**Final Drainage Report Addendum
Peaceful Ridge at Fountain Valley Subdivision
El Paso County, Colorado**

May 2023

PCD File No. CDR-22-015

EX COTTON MEADOWS SWALE - Q100 = DP20 = 10.9 CFS

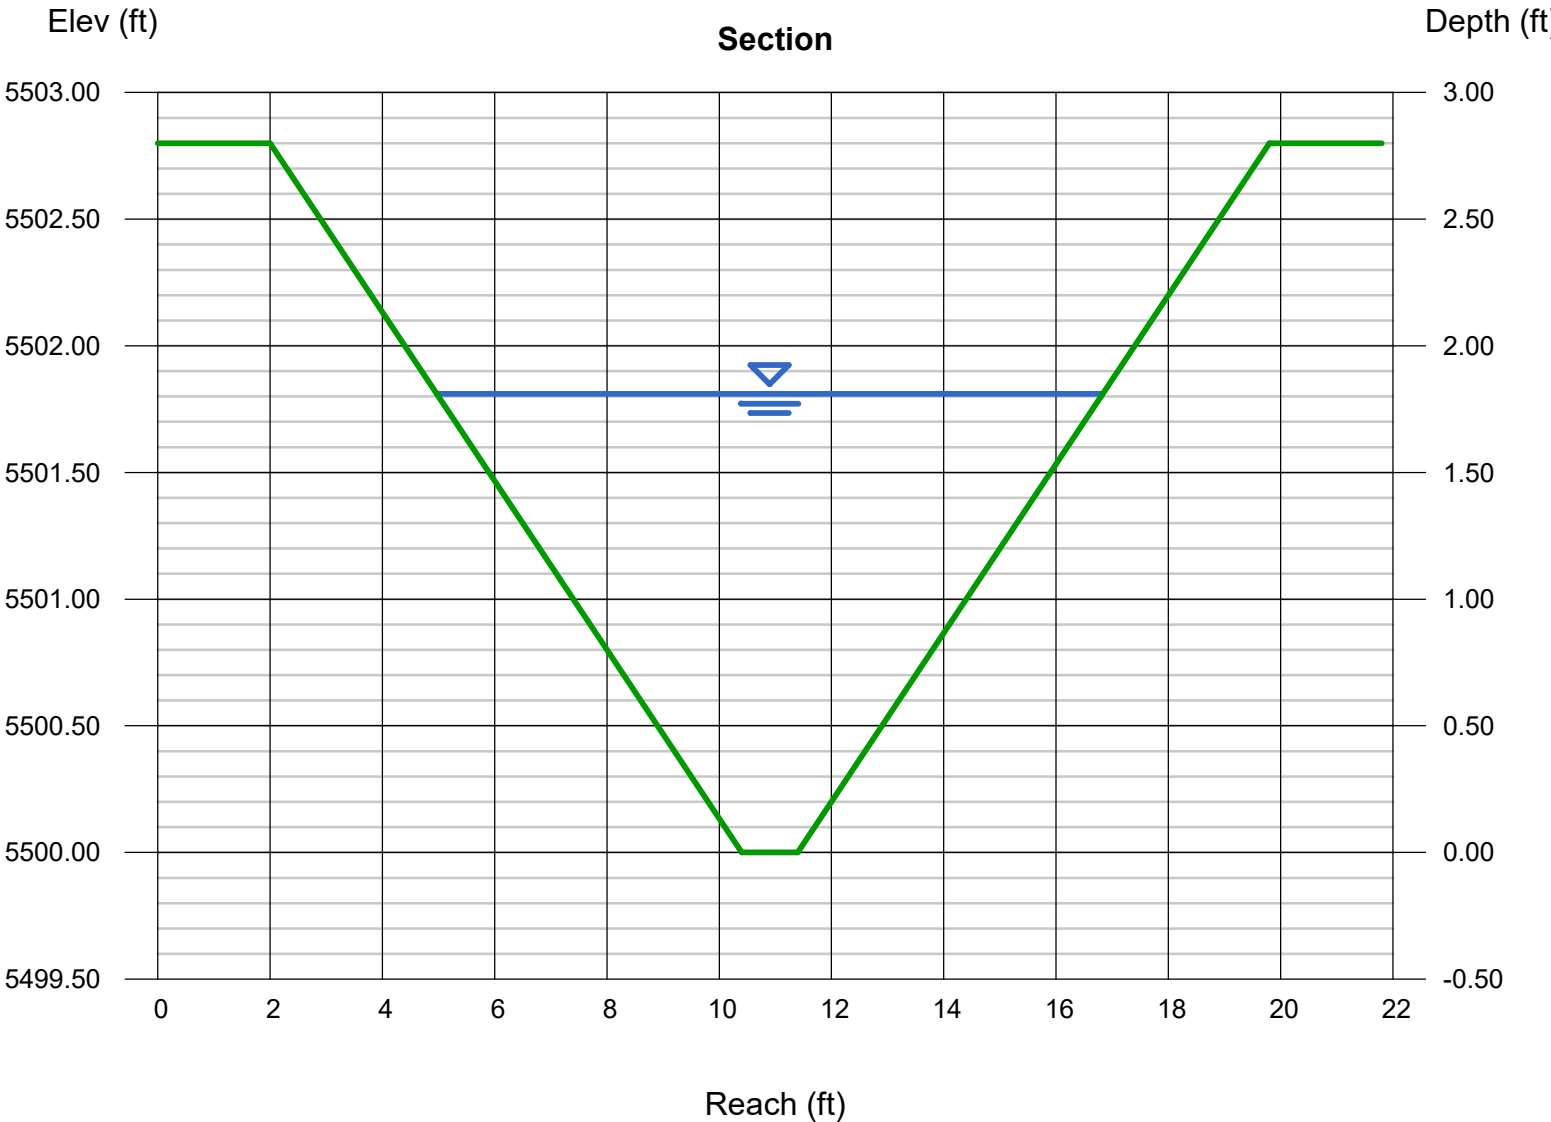
It appears this flow is only accounting for this subdivision's contribution to the channel. Revise to include Cottonwood Meadows' flows that drainage to this channel.

DETENTION BASIN STAGE-STORAGE TABLE BUILDER

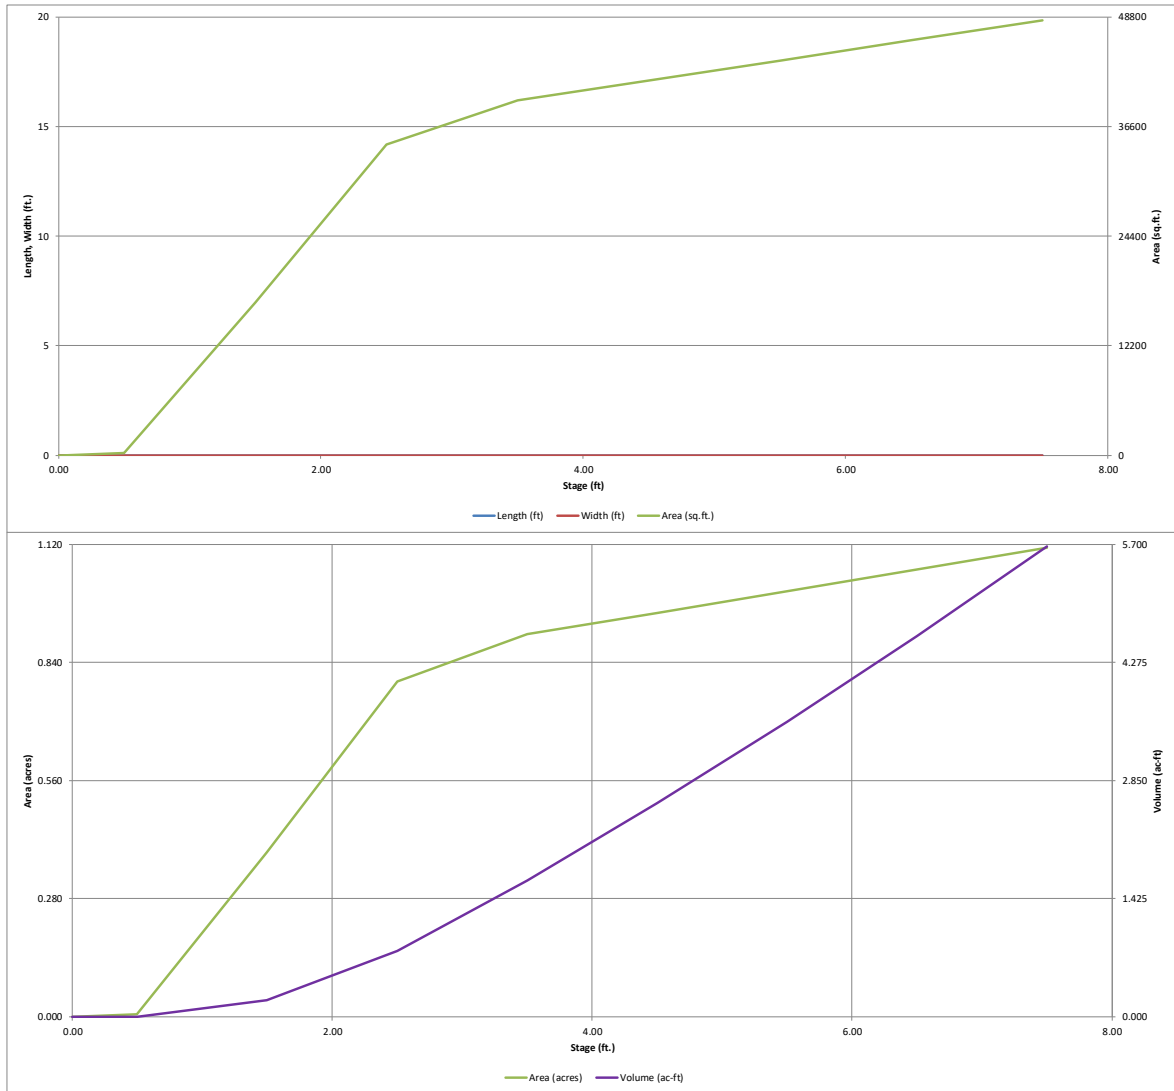
Unresolved from review 1. It does not appear that this sheet has been updated to match what was approved. Discuss in a narrative what changes are being proposed and why. It appears a smaller pond would be needed with these calculations.

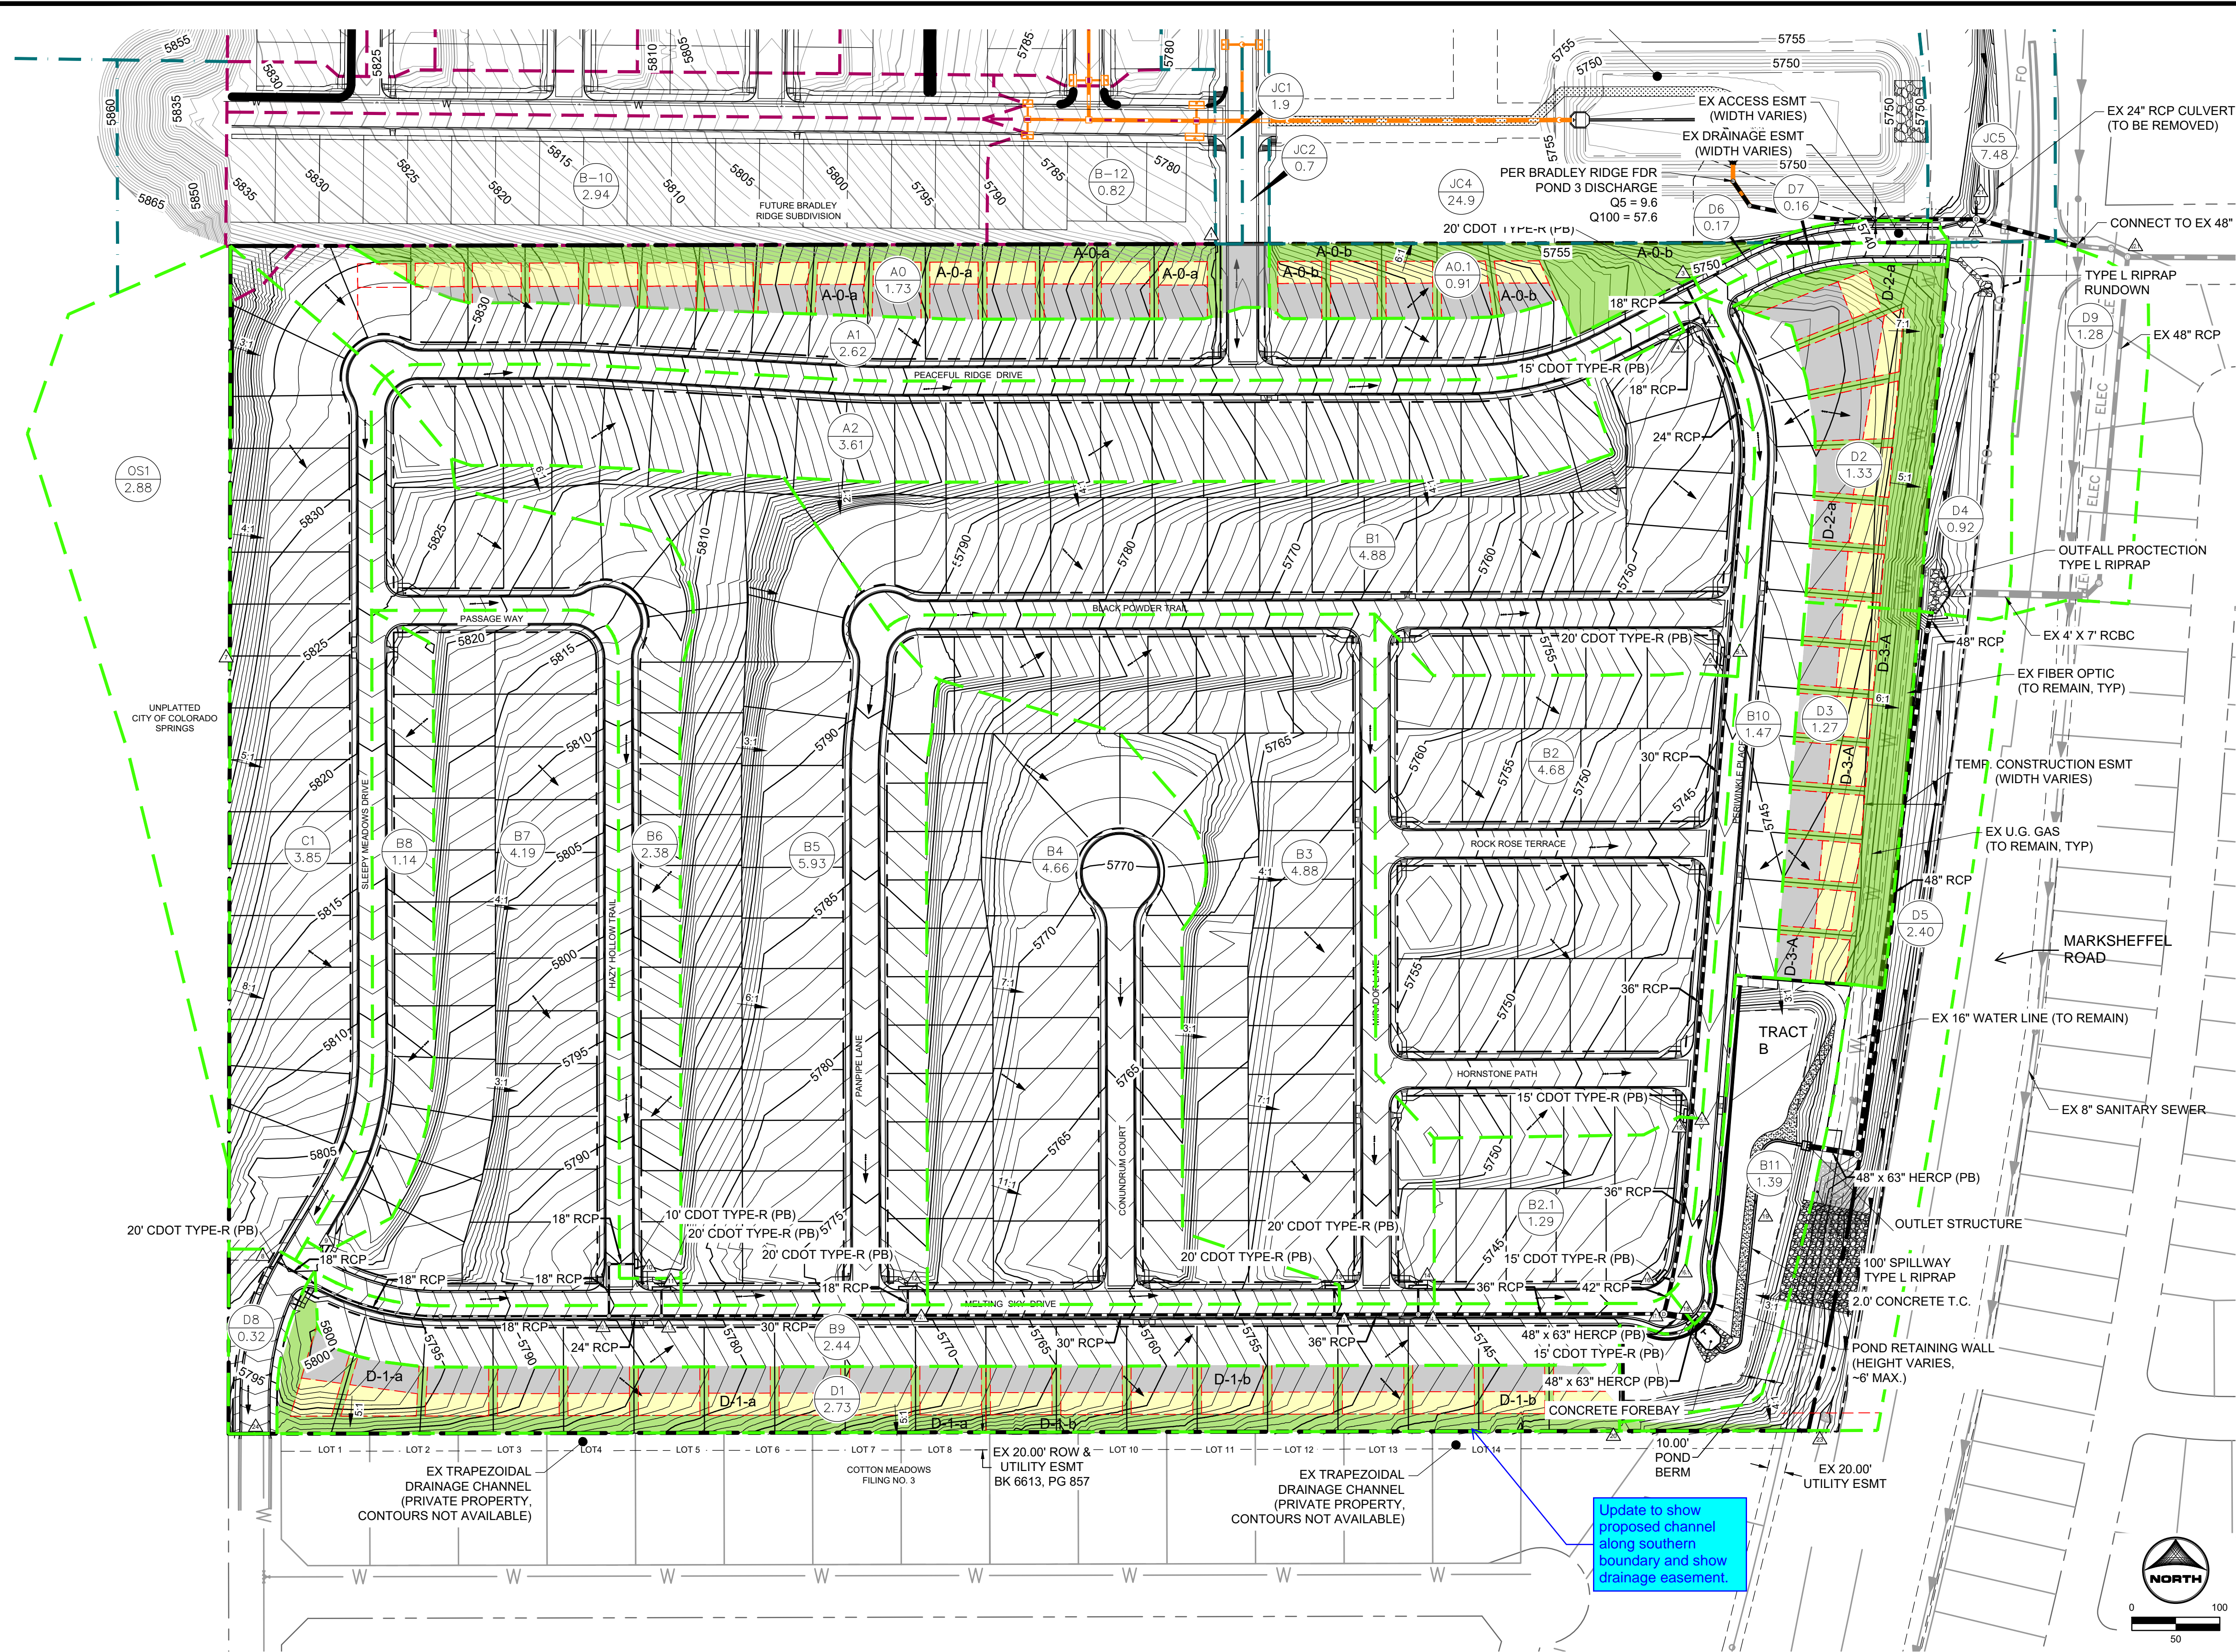
Update to show proposed channel along southern boundary and show drainage easement.
